REQUEST

Current Zoning: R-3 (Single Family Residential)
Proposed Zoning: UR-2(CD) (Urban Residential, Conditional)

SUMMARY OF PETITION

The petition proposes redevelop 3 single family parcels with a townhome community containing 20 single family attached dwellings at a density of 9.62 dwelling units per acre (DUA).

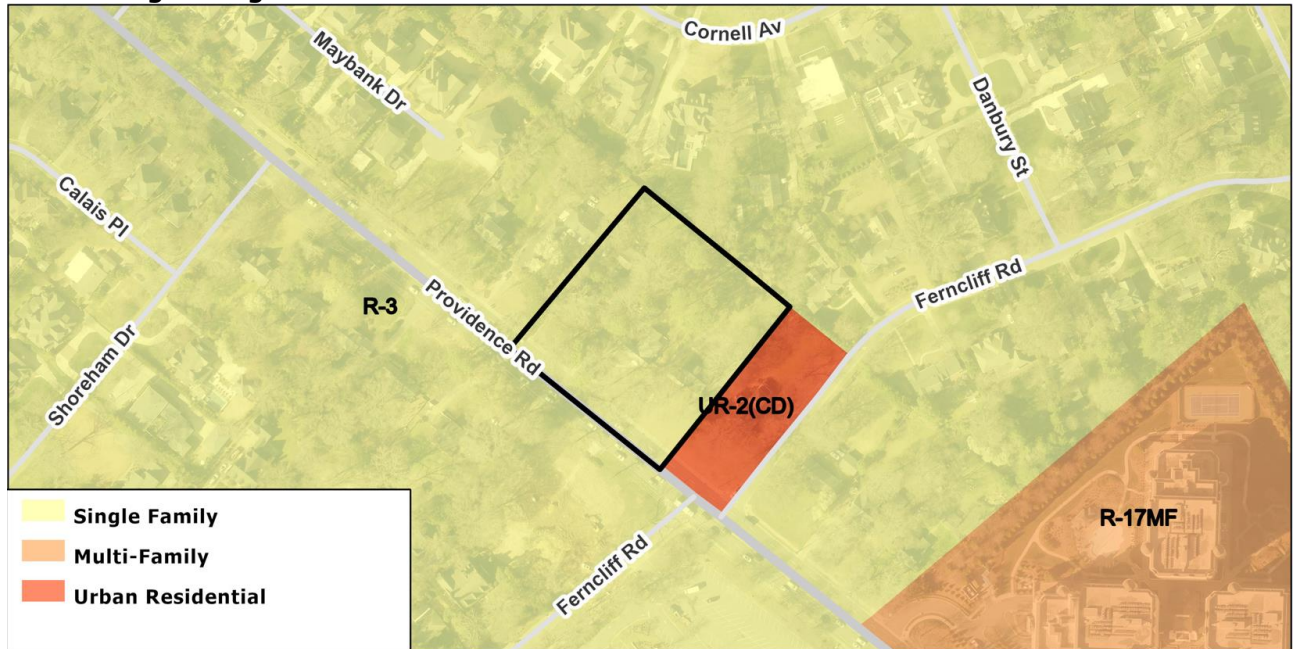
1. ~~Increase the side yards. Staff requests 10 ft to match the yards provided with the adjacent UR-2 development.~~ Addressed, increased the site yard adjacent to single family zoning to 10 ft.
2. ~~Relocate the dumpster away from the adjacent residential use.~~ Addressed

3. Remove Note IV 10 under Architectural Standards as the site plan remove the proposed gate. Not addressed.
4. Add parcel 18110408 for possible connection in Note III.3., the parcel is zoned single family but developed with multi-family use. Possible connection shown, but not added to Note III.3.
